**RE:** UNM Starbucks and Freddie's  
Grading and Drainage Plan  
Engineer's Stamp Date 2-22-2017 (File: K16D075)

**RE:** UNM Starbucks and Freddie's  
Grading and Drainage Plan  
Engineer's Stamp Date 1-27-2017 (File: K17D075)

DRAINAGE REPORT

**STARBUCKS/FREDDIES**  
**2550 CENTRAL SE**  
**Albuquerque, New Mexico**

| DAVID SOULE<br>NEW MEXICO<br>REGISTERED PROFESSIONAL ENGINEER<br>14522<br>2/22/17 | GRADING AND DRAINAGE PLAN  | DATE<br>2-22-17      |

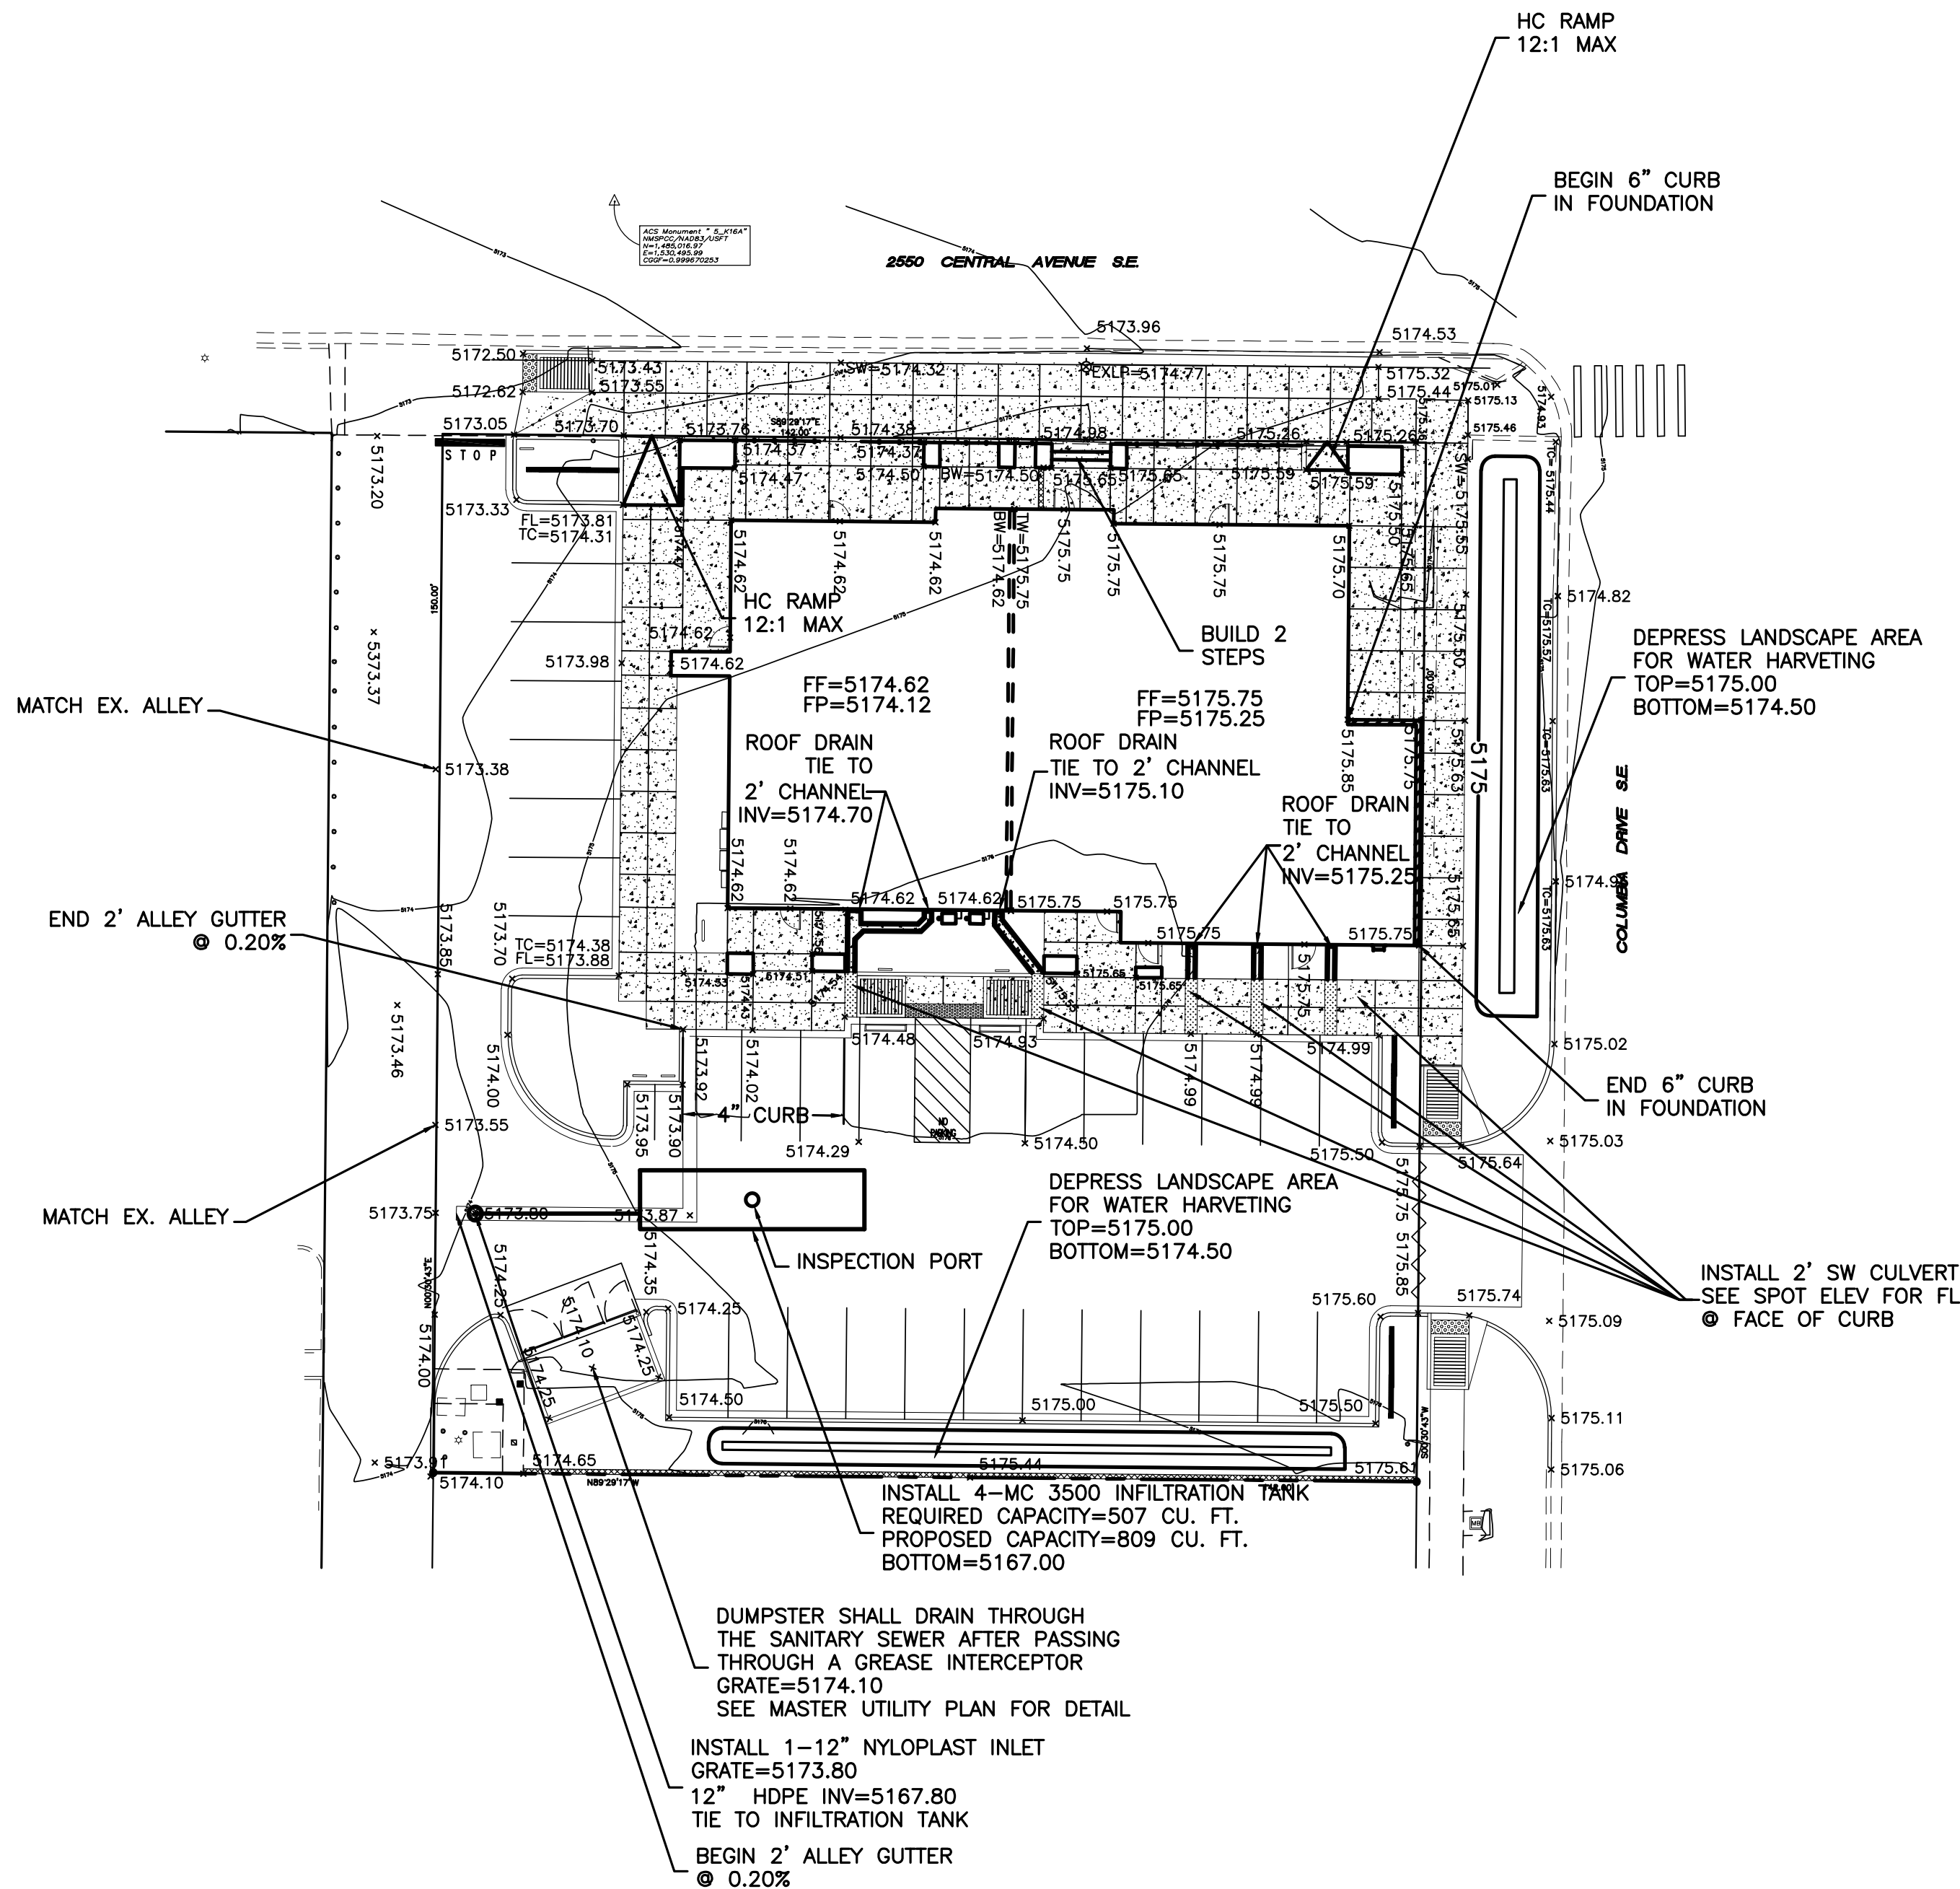
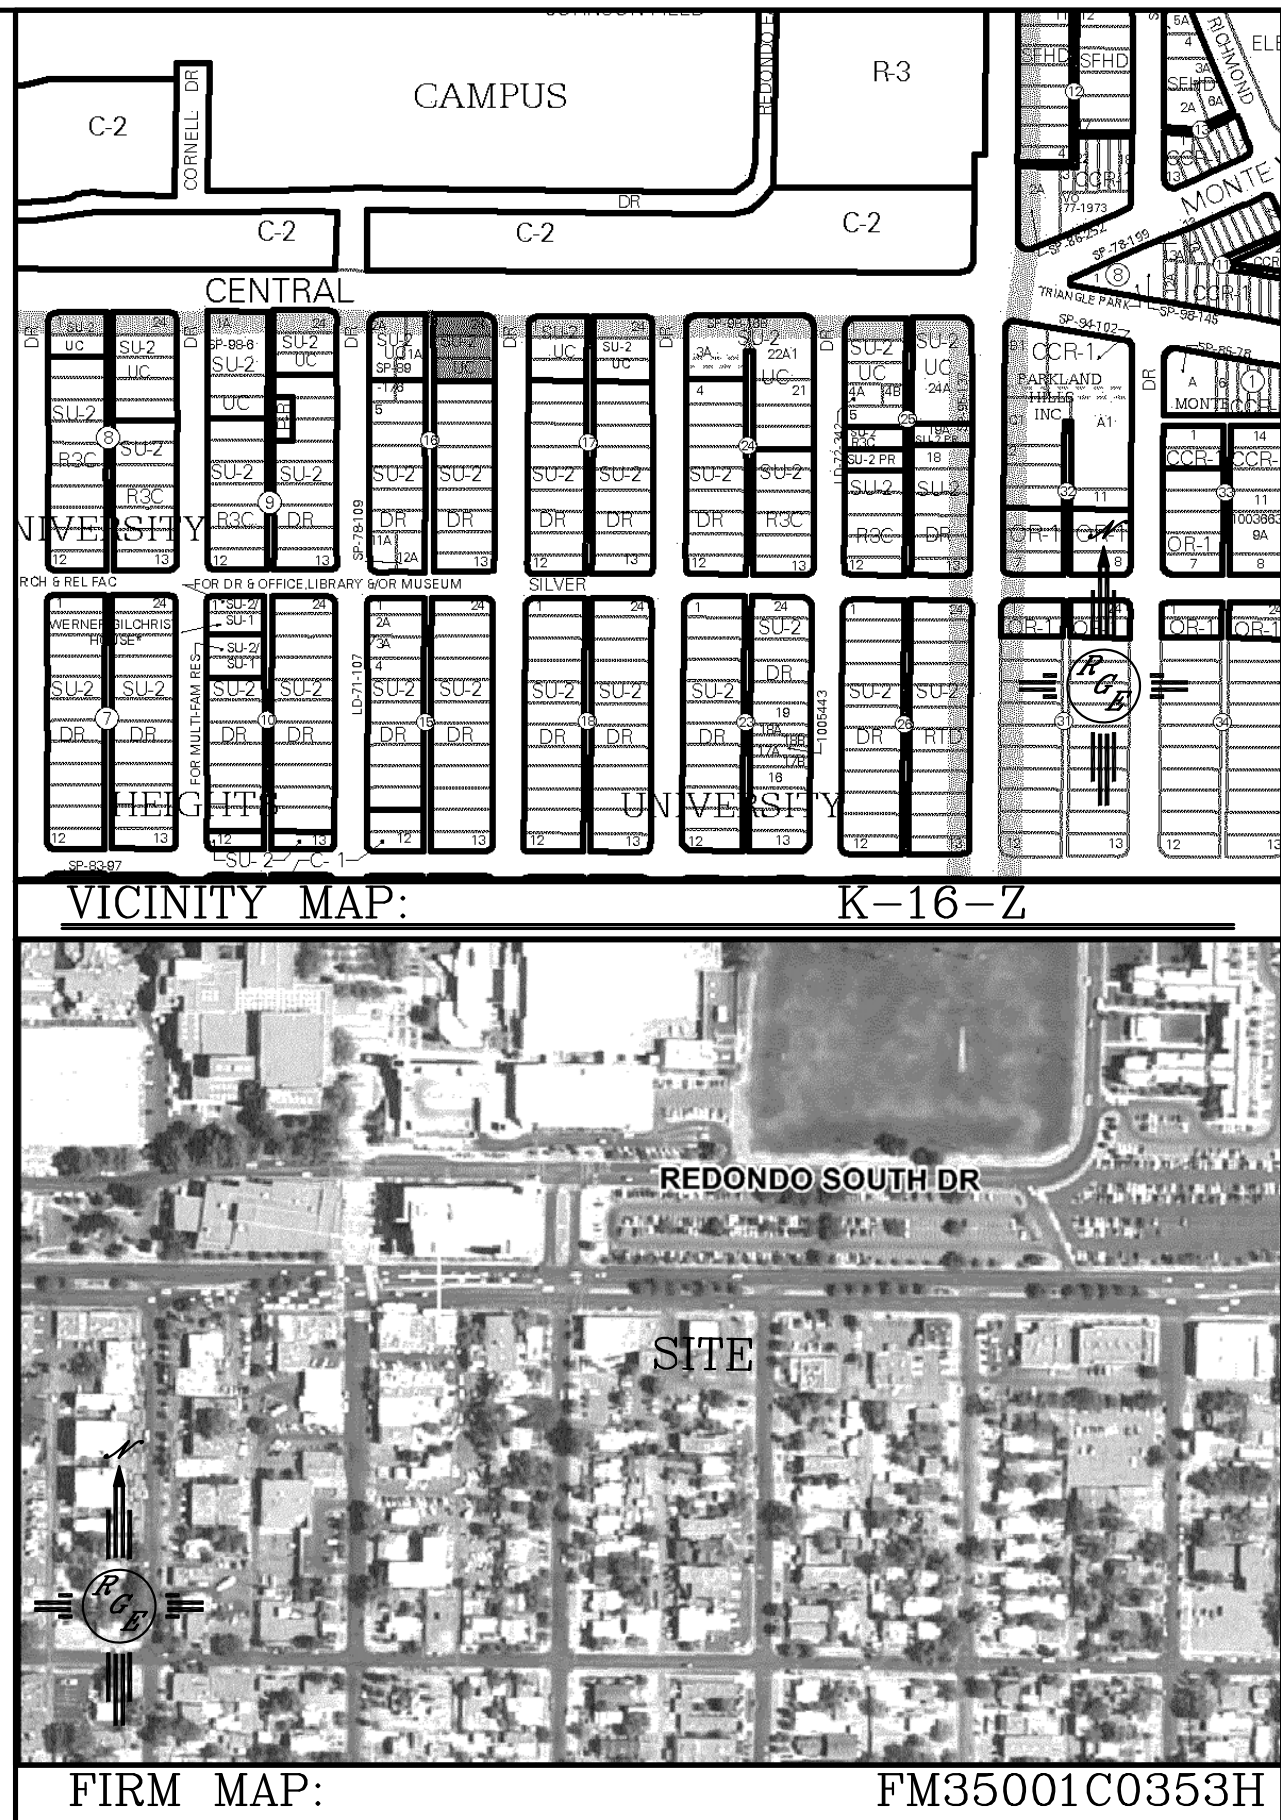
Based upon the information provided in your submittal received 1-30-2017, the above referenced Grading and Drainage Plan cannot be approved for building permit until the following comments are addressed:

1. Provide build note and grade elevation for the dumpster.
2. Provide narrative for offsite flow.

THIS SITE IS A REDEVELOPMENT OF AN EXISTING SITE . THE EXISTING SITE DISCAHRGES 2.22 CFS TO A PUBLIC ALLEY. THE PROPOSED DEVELOPMENT GENERATES LESS THAN EXISTING FLOW RATES. THE FIRST FLUSH VOLUME WILL BE RETAINED BY THE PLACEMENT OF A INFILTRATOR SYSTEM AT THE OUTFALL FLOW LINE. THE SITE MATCHES THE EXISTING DRAINAGE PATTERNS. AND WILL TIE TO THE EXISTING ALLE NO UPLAND FLOWS IMPACT THE PROPERTY, DUE TO WATER CURB AND GUTTER AND WATER BLOCKS AT DRIVEWAYS
